From: Wideman Steve G
Sent: Tuesday, February 26, 2013 8:29 AM
To: 'Lyon, Fred'
Cc: Muilenburg William T; Peabody Charles A; 'Ron.Kopriva@nrc.gov'; Wagner Pat G; Herrman Paul J; Broschak John P; Westman Mike J; Fredrickson Kenneth L
Subject: RE: Steam Generator Inspections for Upcoming RFO

Fred - in accordance with the below email of February 1, 2013, this email is to make you aware of two items identified during the current refueling outage Steam Generator (SG) Inspections. If it is determined that a conference call is needed, please let Bill Muilenburg and myself know.

Burst Resistance vs. Percent Degraded Area Acceptance Limit
11/16" x 0.040" Alloy 600TT SG Tubes at 650°F ETSS 20510.1
Indication Measured PDA = 11% assuming through-wall

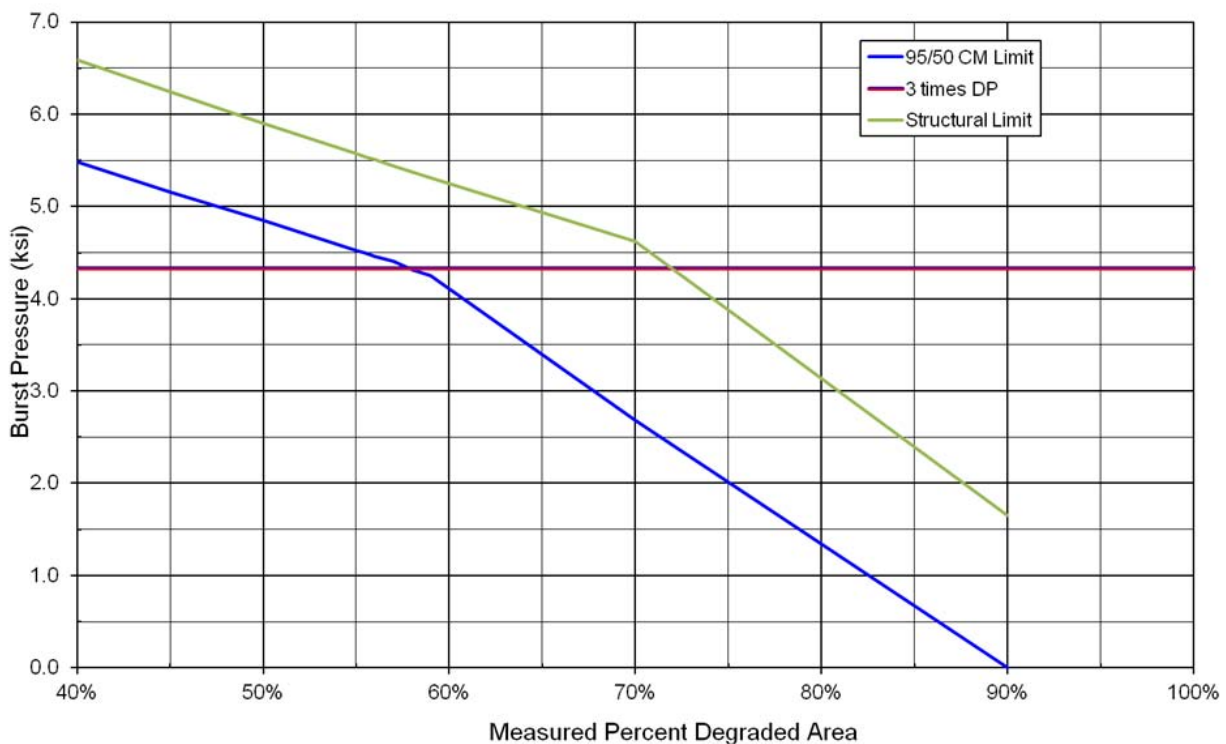
Related to Item 2, See the following graph related to the Condition Monitoring limit for the circ indication.

The steeper slope is tensile instability which relates to separation within the tubesheet. The shallower slope presumes that tube could bend at top of tubesheet and is conservative relative to locations within the tubesheet. In any case, the allowable percent degraded area (PDA) for 3 delta P considering all uncertainties is 58% and the measured PDA is 11%.
